Our Case Number: ABP-313892-22

Re: Bus Connects Blanchardstown to City Centre Core Bus Corridor Scheme

Re: Bus Connects Blanchardstown to City Centre - ref ABP-313892-22

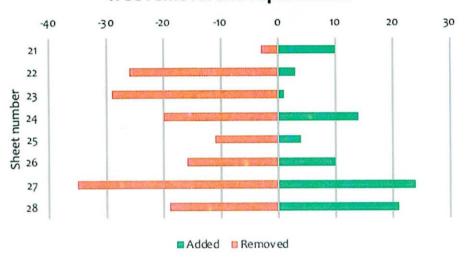
Again, I welcome that overall there will be an increase in trees along the BusConnects route. However, the NTA choice of the stretch of road for which statistics were provided in its response to highlight tree planting from Parkway station downplays the extent of tree removal along footpaths on the Navan Road between the Halfway House and Old Cabra Road. About 60% of the 230 trees mentioned in the NTAs response are proposed to be planted between Navan Road Parkway and the current Ashtown Roundabout (sheets 18-218) or are not directly along the footpath where existing trees will be removed. Within the current proposals, the 2.5km segment of the Navan Road between the Halfway House and Old Cabra Road will have a significant amount of tree removal, with limited replacement trees (sheets 22 to 27).

This part of the BusConnects route is expected to have 38.5% of tree removal for the whole scheme but only 11% of replacement tree planting⁹. The issue is particularly severe for the south side of the Navan Road where I estimate 84 trees are planned to be removed but only 20 replaced (a 76% reduction), with replanting concentrated outside the Belvedere sports grounds and outside the Eir premises near Hampton Green. See annex 2 for a summary of the relevant maps.

The significant impact of the loss of trees has been recognised by the NTA in relation to sheet 23/23 at least (see above regarding figure 2.2.23), however, no additional efforts to mitigate the impact have been proposed.

- To achieve significantly reduced tree removal or significantly increased replanting along the Navan Road from the entrance to Kempton to Skreen Road so that the number and placement of trees is consistent with Design Manual for
- 2. Urban Roads and Streets (DMURS) guidance of at least every 14-20 meters apart².
- 3. Where replanting is the chosen option that a diversity of trees are planted, while disease susceptible trees such as Sorbus Aria are avoided.

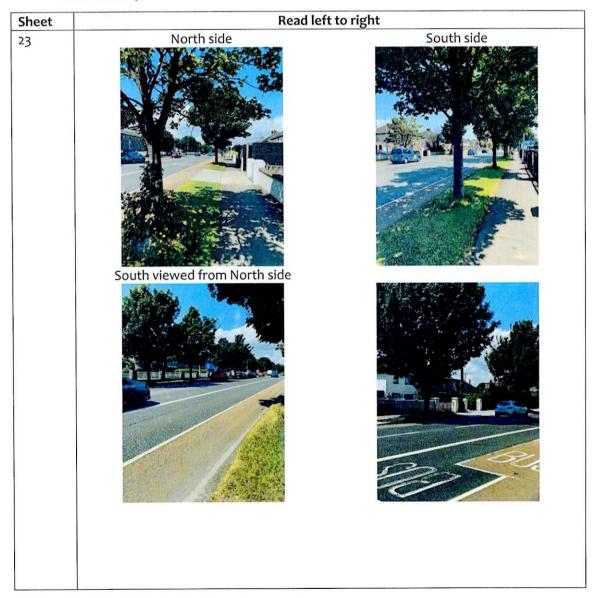
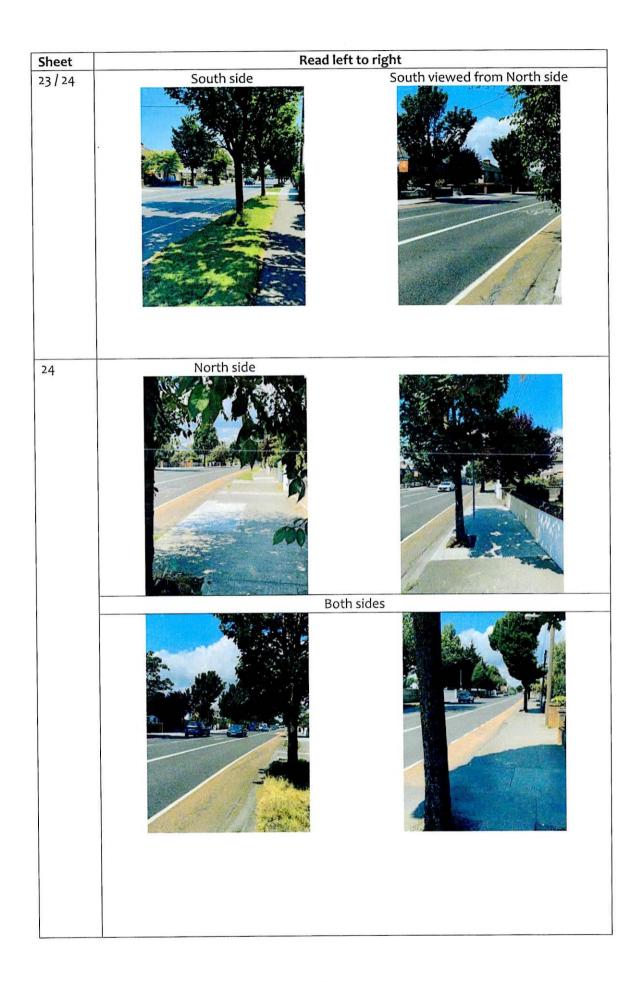
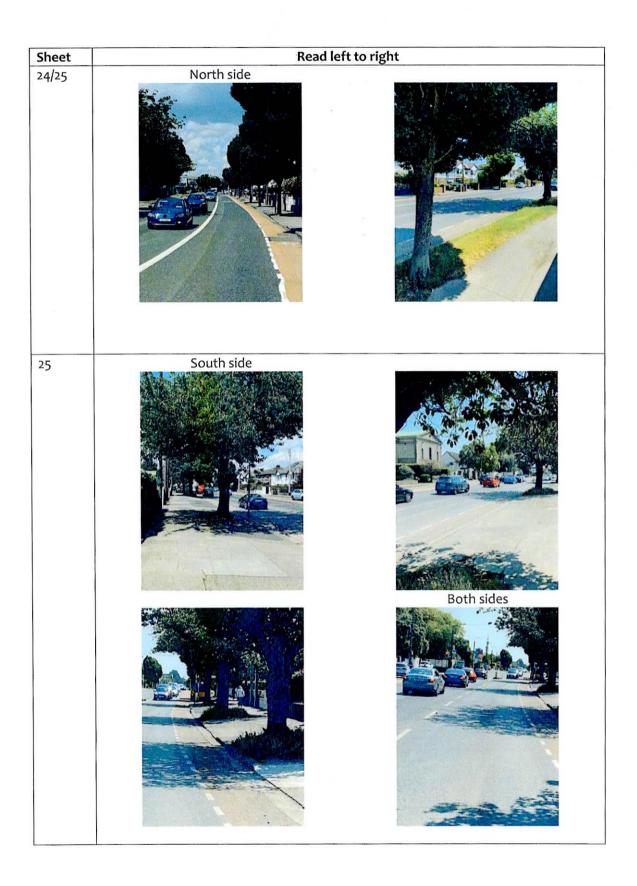
The following stretches of road, under the current plan, would have a significant change in their character and would appear to be completely mis-aligned with stated policy objectives under DMURS in relation to street trees. If implemented as planned, it is likely that people along the route would be more likely to use their cars rather than walk or cycle and would lose the positive impacts in terms of air quality, shade, mental wellbeing and safety when using the road:

- Kempton entrance to Kinvara Ave/Baggot Rd junction, in particular the South side of the road where there is no new replacement tree planting
- Garda station to Tesco, on the South side, bar planting away from the path near the entrance to Hampton Green
- Parts of the North side of the road between Kinvara Ave junction and 157 Navan Rd

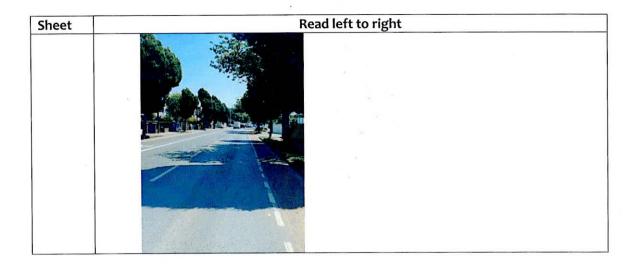
Many of the photomontages for the proposed view within the NTA response include images of double decker buses that obscure the view and do not make it clear whether there would be replacement trees behind where the bus is shown – e.g. Figures 2.2.27, 2.2.29, 2.2.31, 2.2.33 and to a lesser extent Figures 2.2.23 and 2.2.25.

As an alternative to the photomontages presented by the NTA, photos of current trees along segments of the Navan Road are provided below. All of these trees are proposed to be removed with most not replaced. These pictures also demonstrate the benefits of the trees in terms of:

Directional signage approaching the junction of Navan, Ashtown and Castleknock Roads

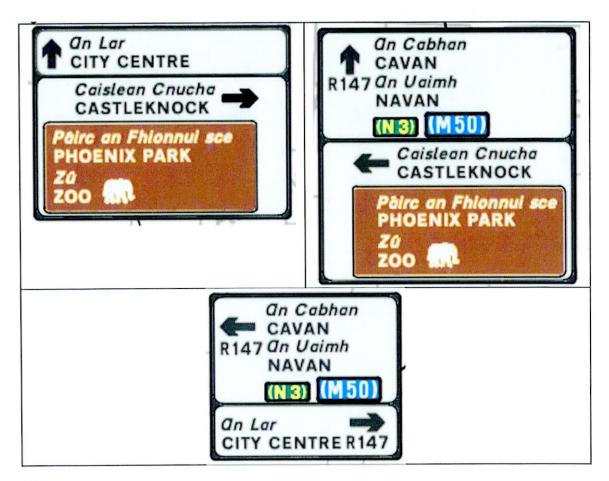
I note that directional signage approaching the junction of Navan Road, Ashtown Road and Castleknock Road does not make reference to the areas of Rathborne and Royal Canal Park which are accessible via Ashtown Road¹¹. With a population of close on 6,000, which will rise above this based on current planning permissions, it is important that Rathborne and Royal Canal

No rationale has been given by the NTA for their refusal to include Rathborne and Royal Canal Park on relevant signage.

It is inconceivable that Westport, Kells, Monaghan or Lusk would not have signage to direct road users towards them. Therefore, it is difficult to understand the logic behind the NTAs refusal to include Rathborne and Royal Canal Park on relevant road signage on the Navan Road as part of the BusConnects Scheme. See annex 1 for a list of towns with a population of between 2,000 and 7,000.

4. That signs approaching the junction of the Navan Road and Castleknock Road at Ashtown (as per drawing BCIDC-ARP-TSM_GA-0005_XX_00-DR-CR-0021³) from the west, east and south include directions to the areas of Rathborne and Royal Canal Park which are situated to the North of the Navan Road at that junction.
